Project: "Residential house Kostelní – Biskupská, Moravská Ostrava"

The opinion to planned construction in proximity of the utility corridor

Residential house Kostelní – Biskupská, Moravská Ostrava

Application for the opinion concerning a possibility to carry out a construction in the proximity of the utility corridor

- Layout drawing
- Section view

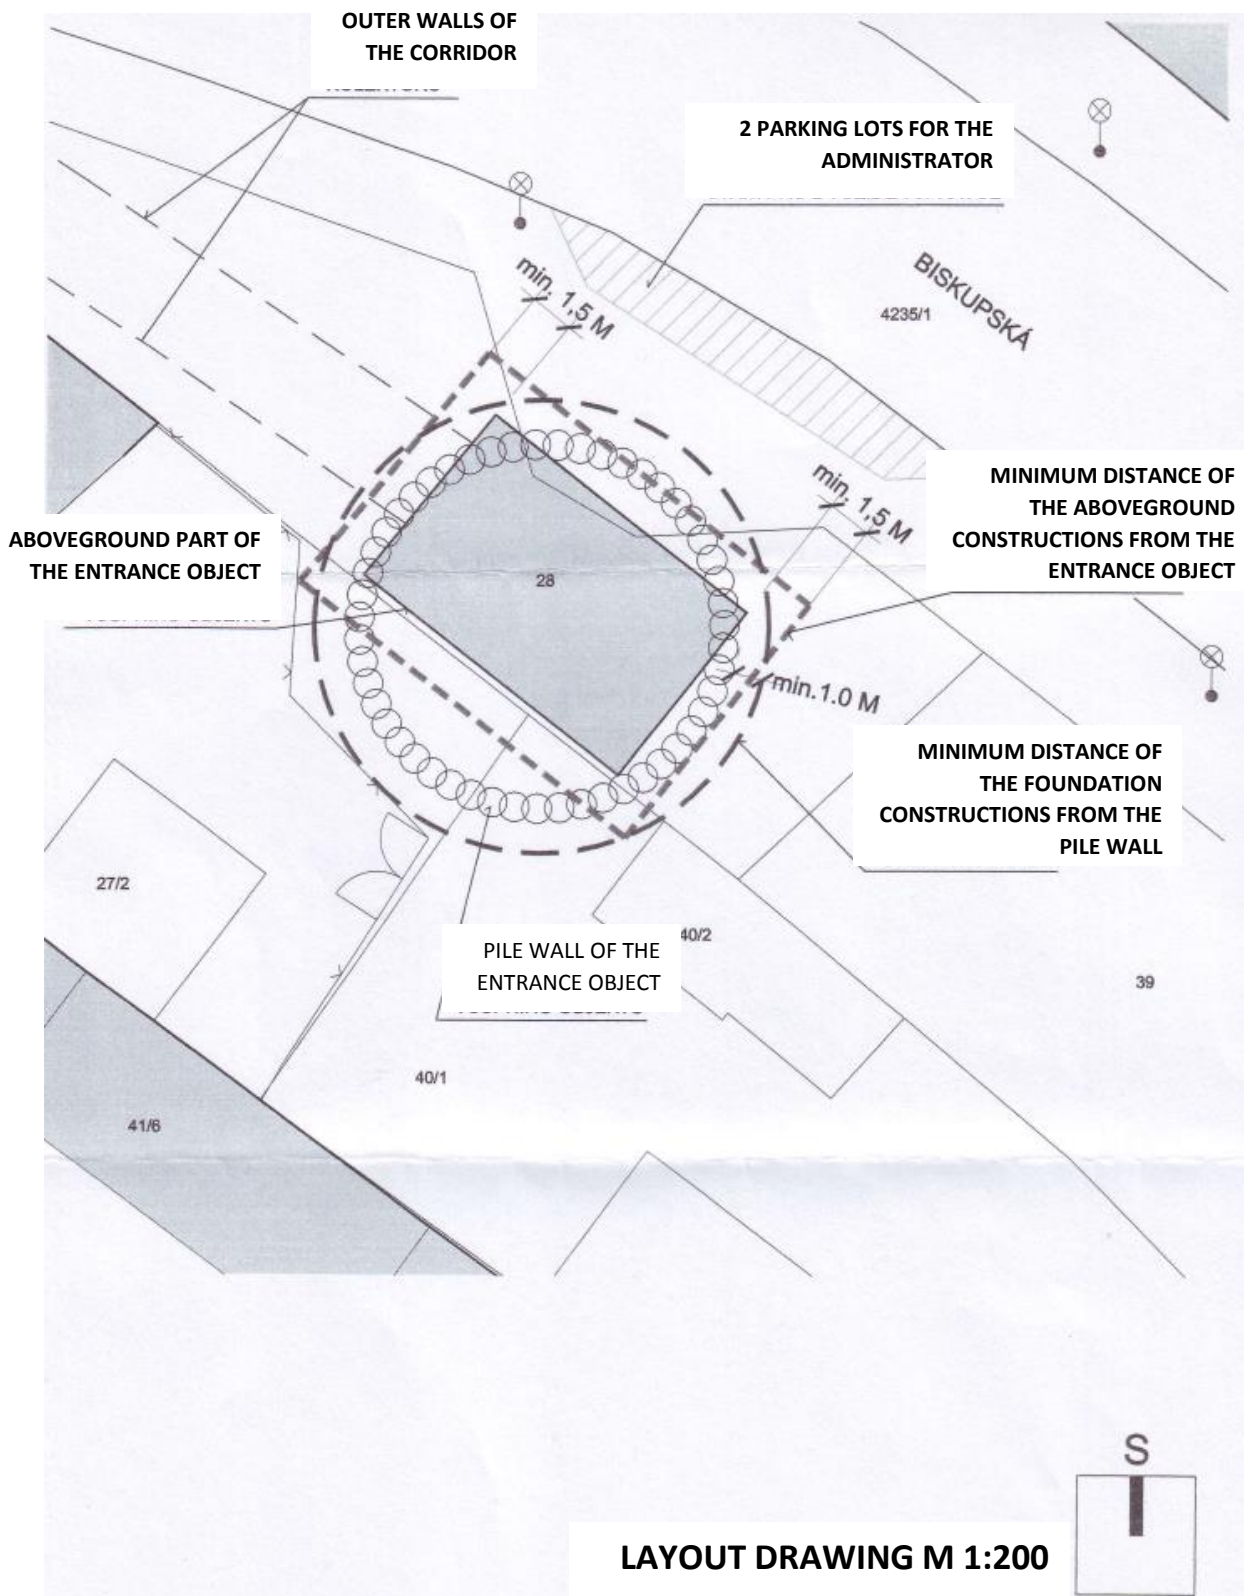
1. Horizontal distance of the base constructions (incl. piles) of the newly proposed object from the pile wall of the entrance object will be at least 1.0 m.

2. The horizontal distance between the piles of the newly proposed object and vertical outer walls of the utility corridor will be at least 1.0 m.
3. The vertical distance between the attic of the aboveground part of the entrance object and the lowest part of the newly proposed object (bridging) above this entrance object will be at least 1.5 m.

4. In the street façade of the newly proposed object, there will be constructed a gate with the dimensions at each side at least by 1.0 m larger than the existing door of the entrance objects, i.e. at least 1.0 m higher and 2.0 m wider than the existing door.

5. Between the existing utility corridor entrance object and the kerb of Biskupská street, there will be constructed a parking bay with 2 reserved parking places for cars of the corridor administrator or alternatively, these two parking lots will be created in the yard and there will be a possibility to access these parking places through the newly proposed object.

The company Ostravské komunikace, a.s., operative administrator of utility corridor Centrum agrees with the planned, above-mentioned construction in the proximity of the central entrance into the utility corridor Centrum under the conditions stated in your application from 9.12.2016, paragraphs 1-5.
